**FORMER JOHN LEWIS DEPOT, LETCOMBE STREET, READING
(ALSO KNOWN AS JLP MILL LANE)**

**LANDSCAPE DESIGN ADDENDUM
SEPTEMBER 2025**

Document reference number: SY743-R-0002 Landscape Design Addendum Sept 2025

General Arrangement - Boundary Treatments, Edges, Steps and Walls

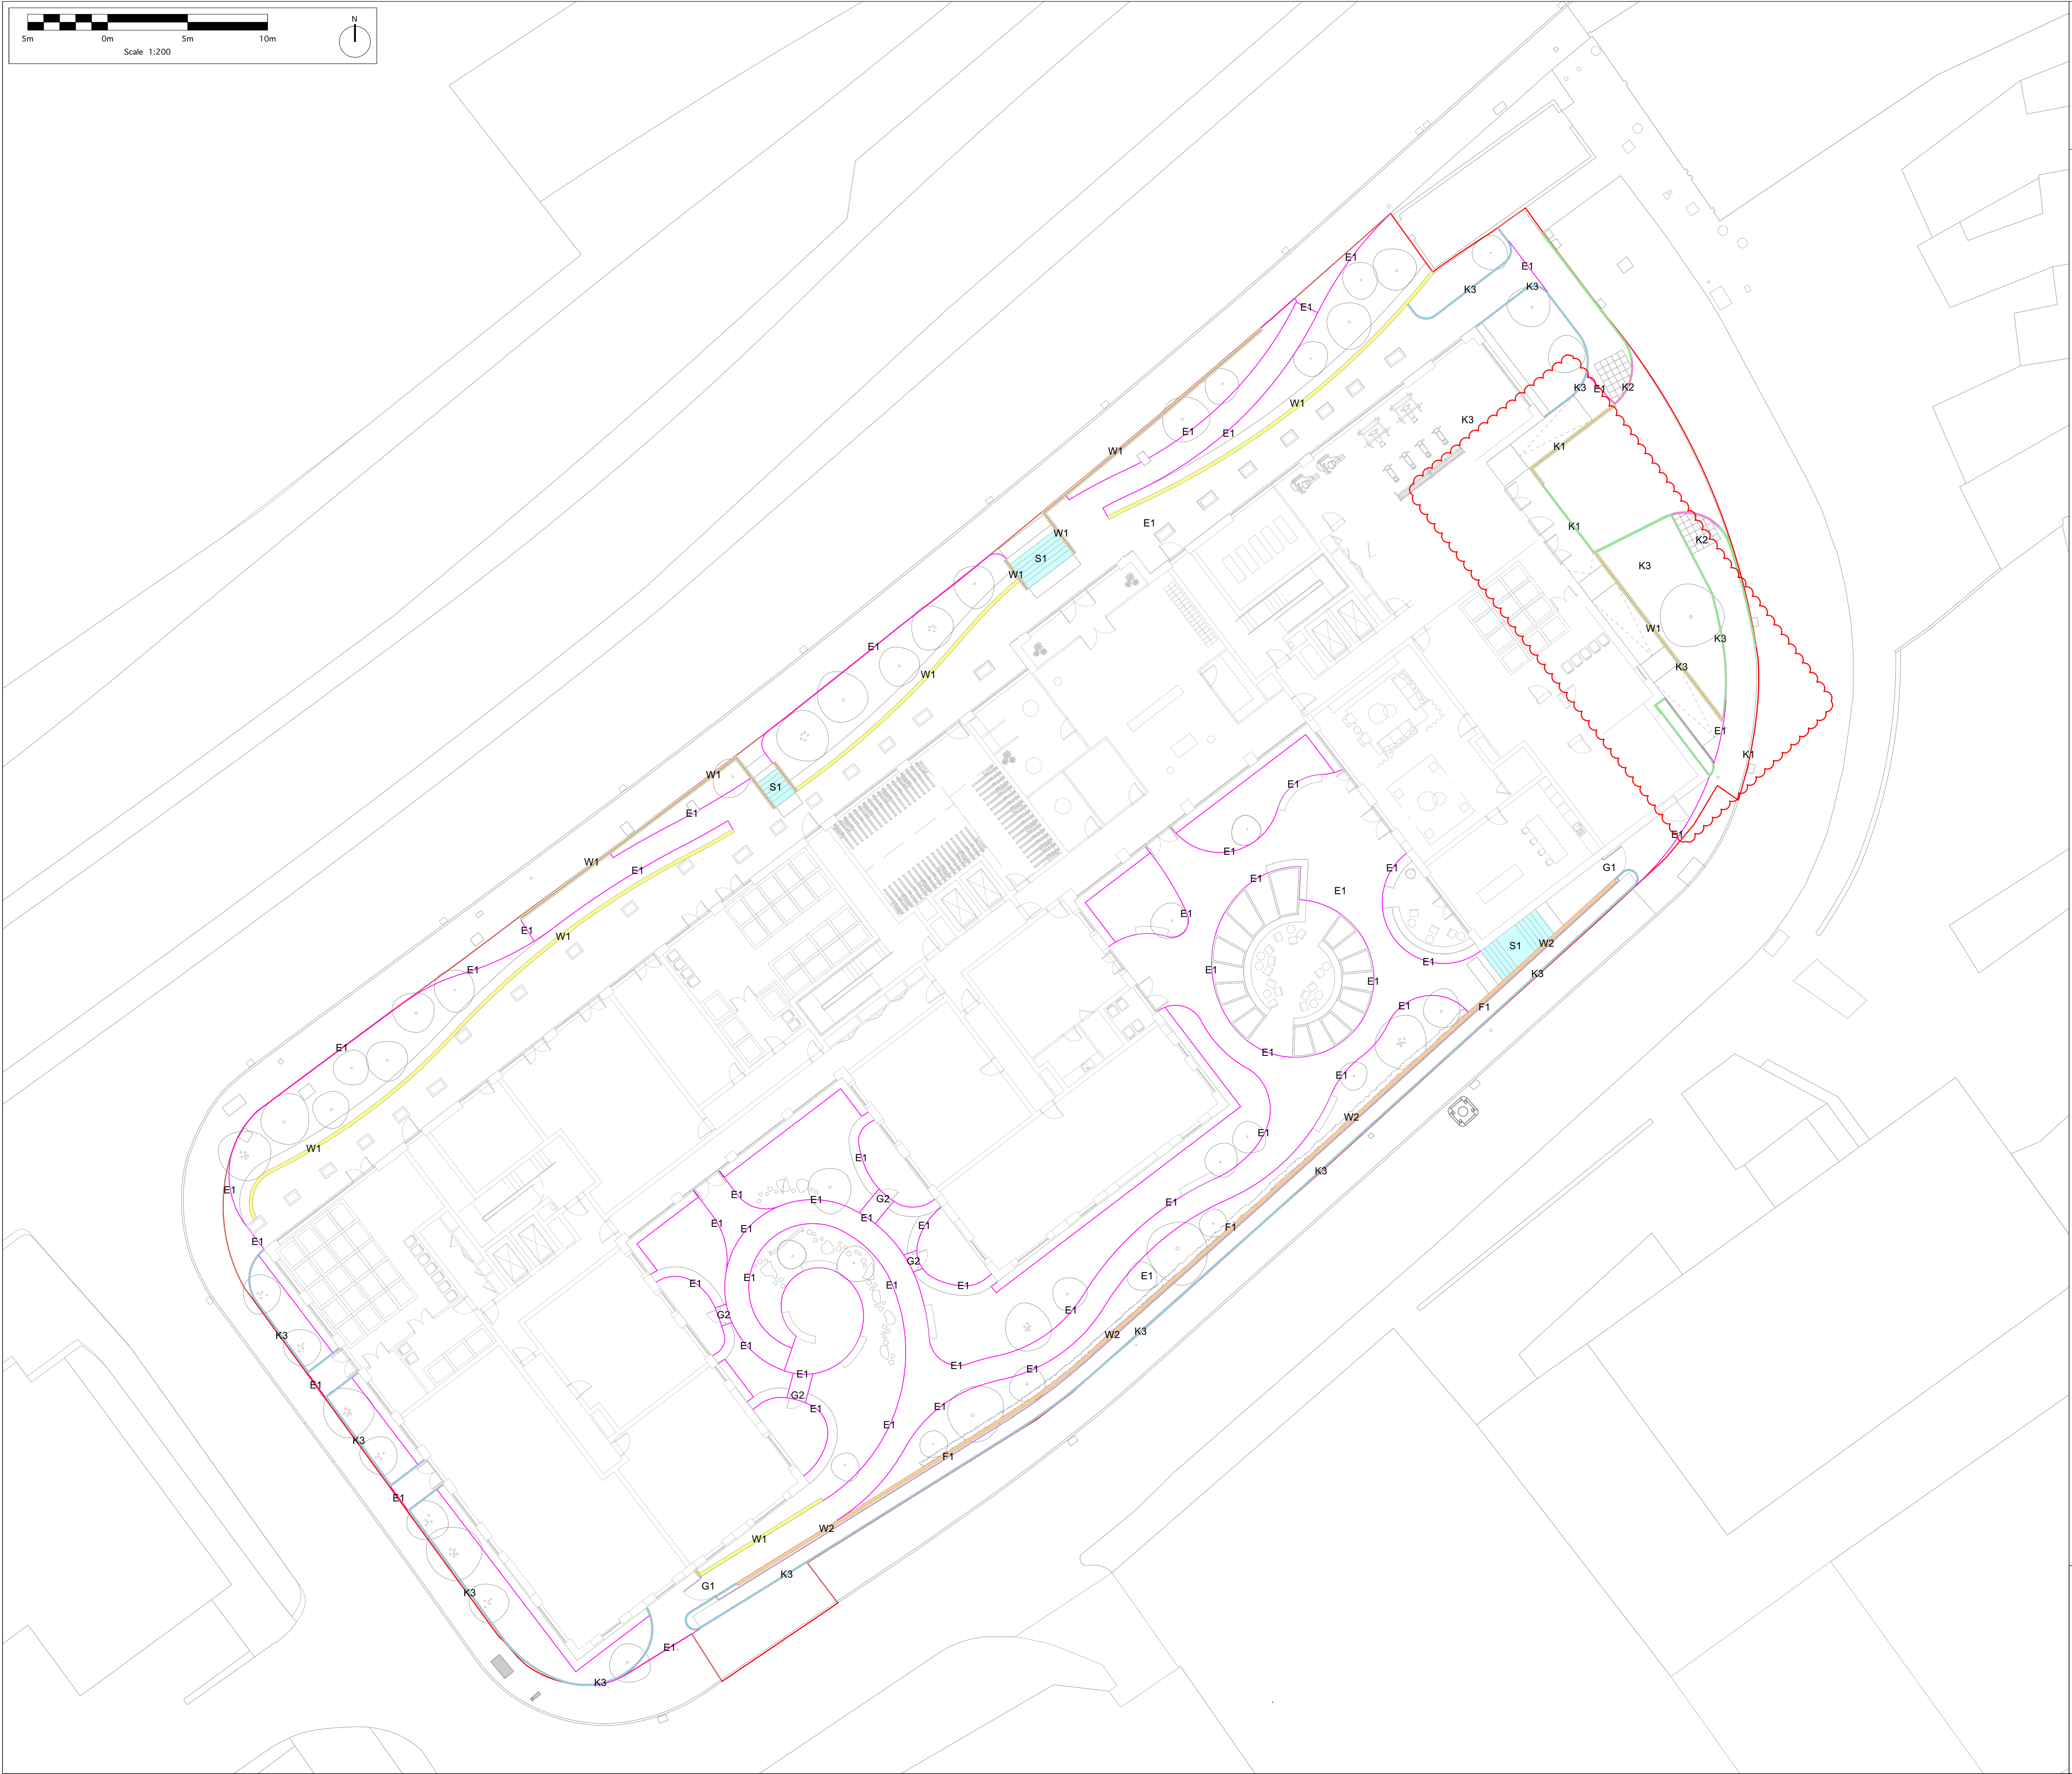
P02	2025-06-19	Steps omitted with ground floor plan update	KS	MSS
P01	2025-06-19	- P01 Issue	LT	PSS
Rev.	Date	Description	Revised by Checked by

General Arrangement - Furniture And Fixtures

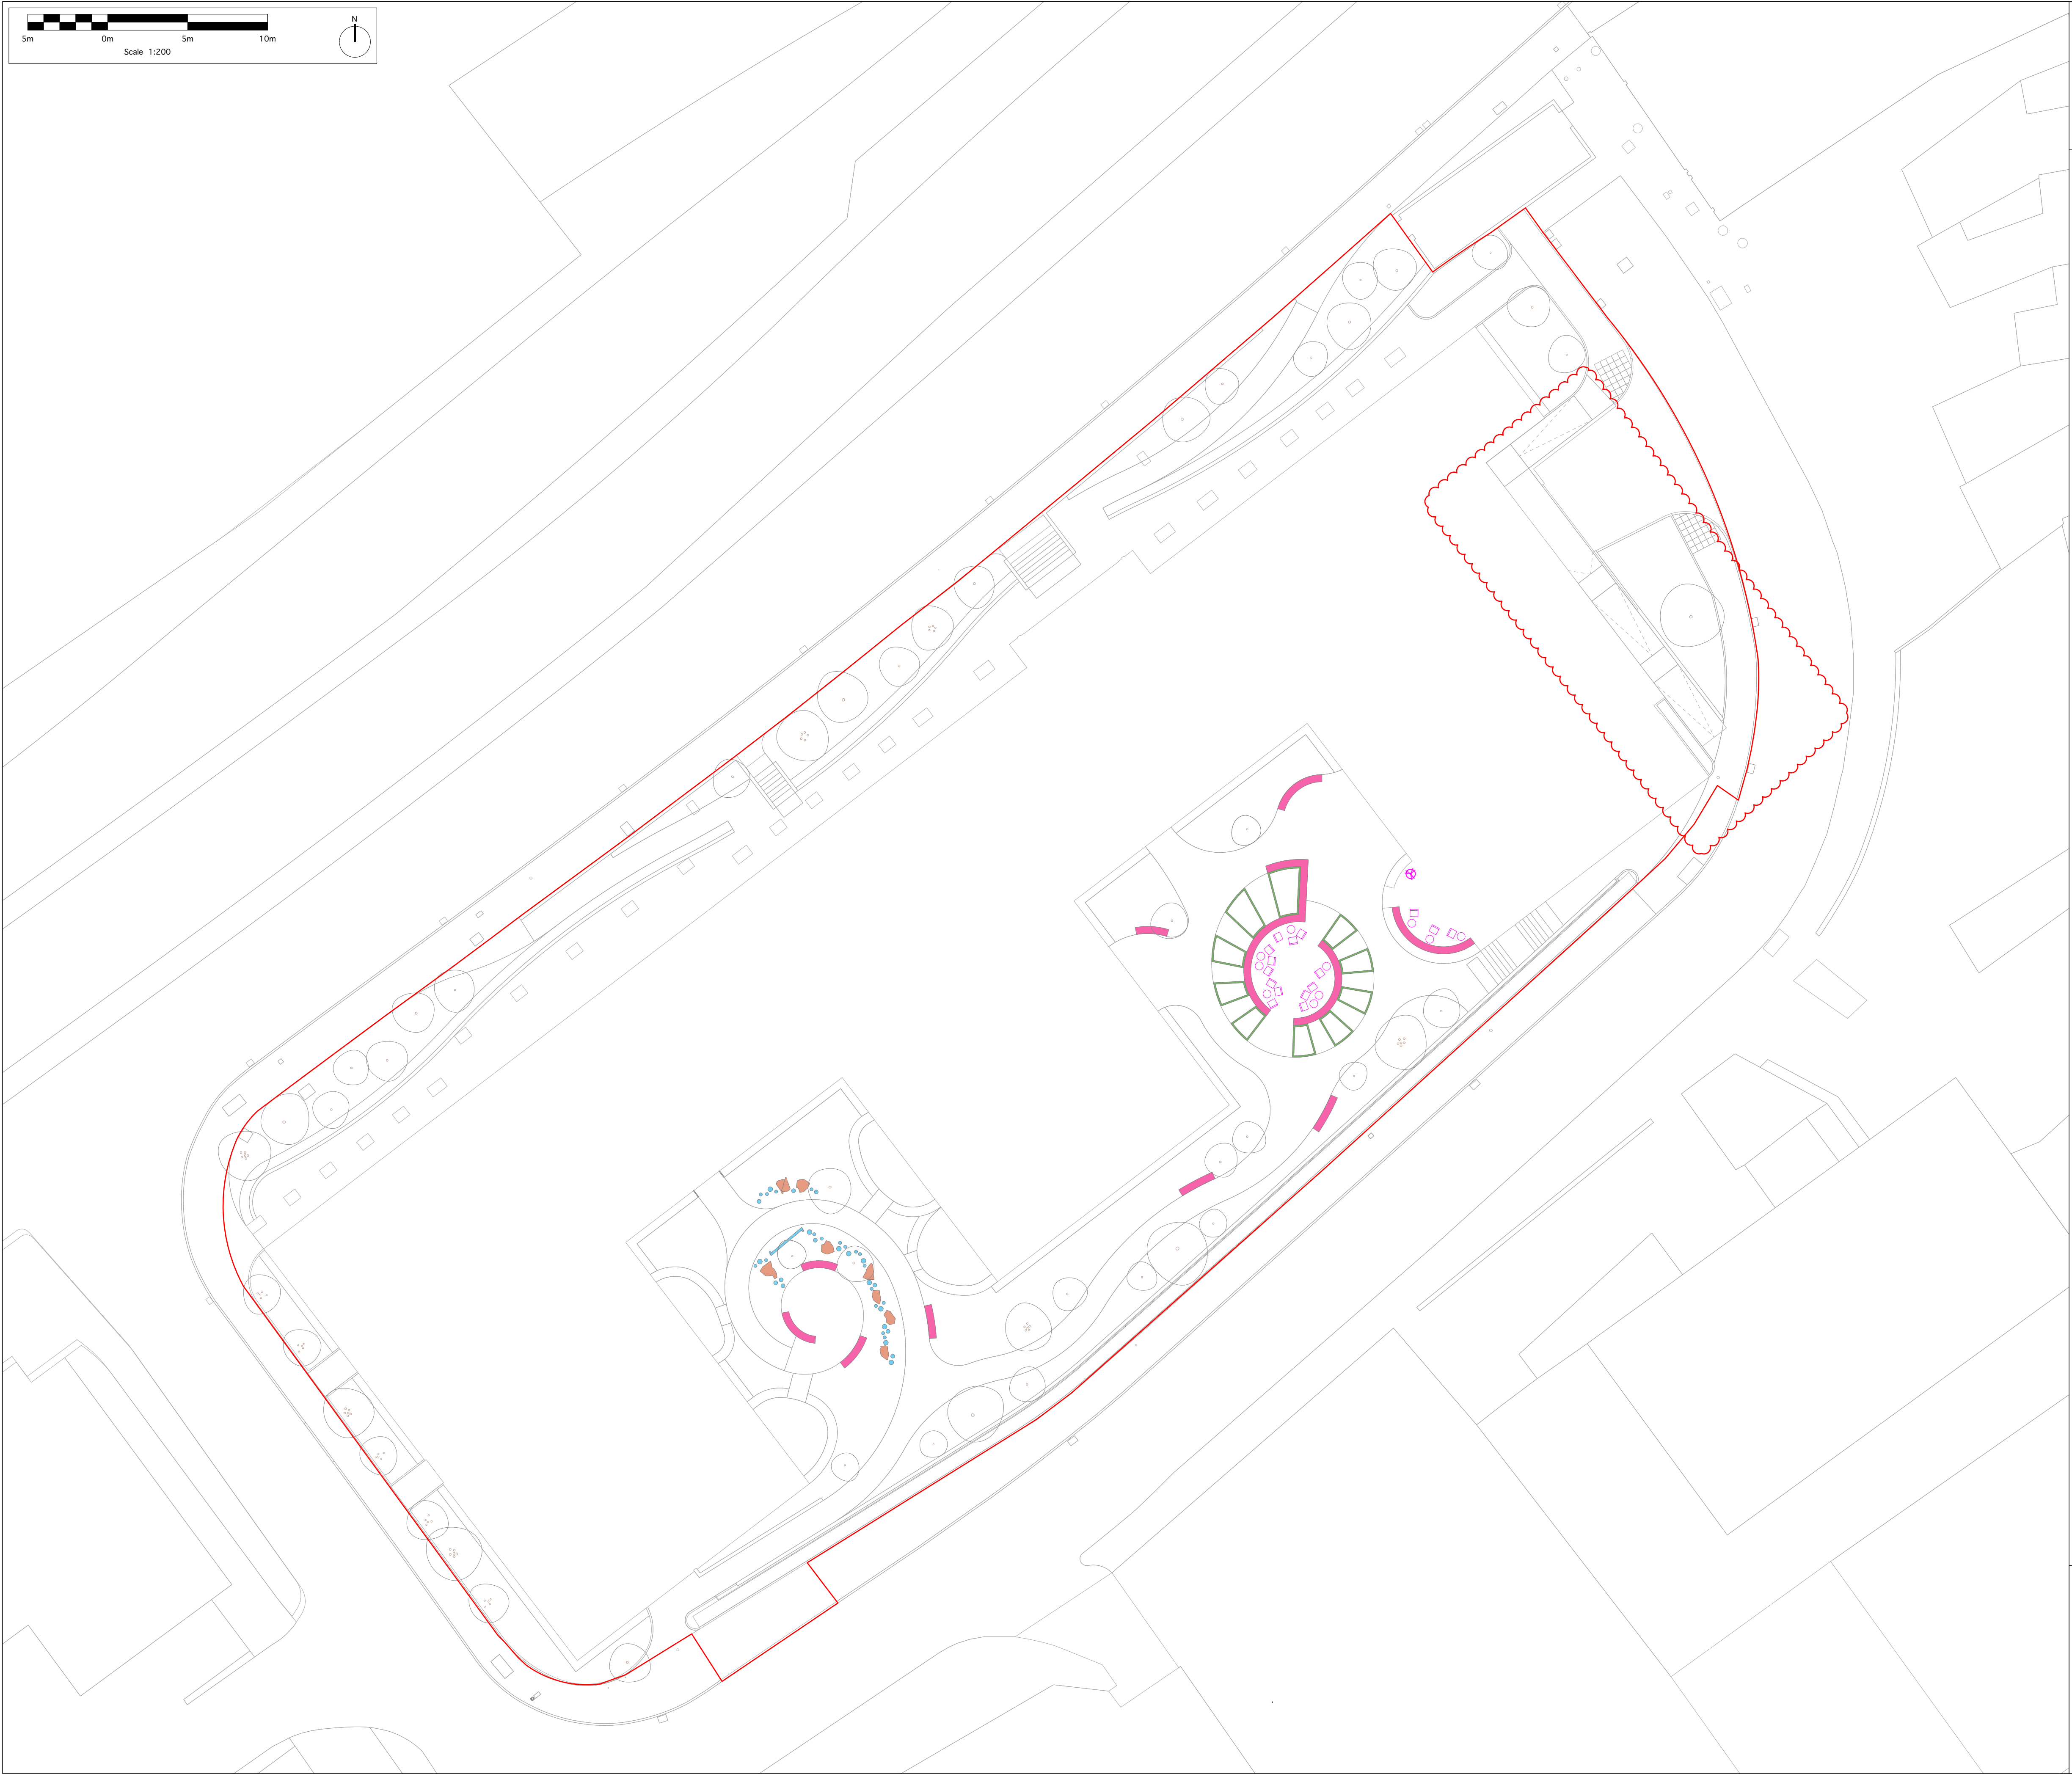
P02	2025-06-10	- Background update, steps replaced by ramp	KS	MSS
P01	2025-06-19	- P01 Issue	LT	PSS
Rev.	Date	Description	Revised by	Checked by
